HIACE

OUTLINE OF NEW FEATURES

The following changes are made for the new Hiace.

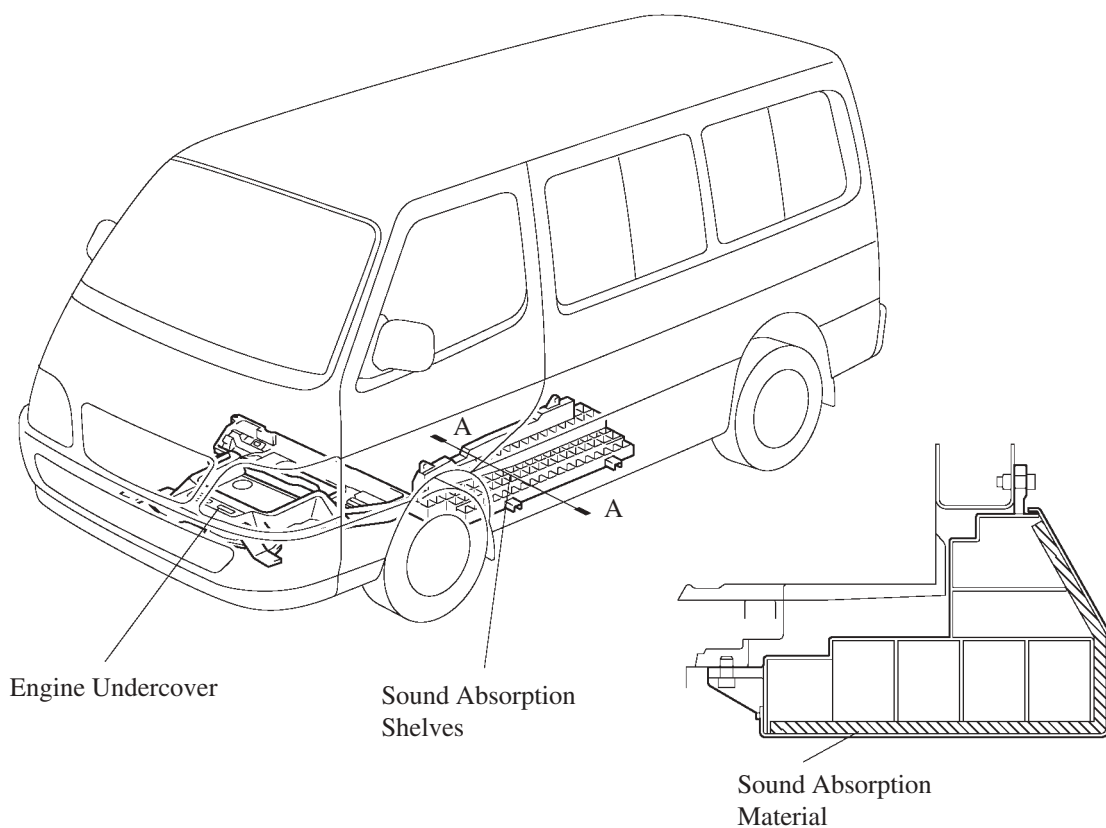
The following new features have been adopted on the Hong Kong model to reduce engine noise:

- Addition of intake resonator
- Adoption of engine undercover and sound absorption shelves
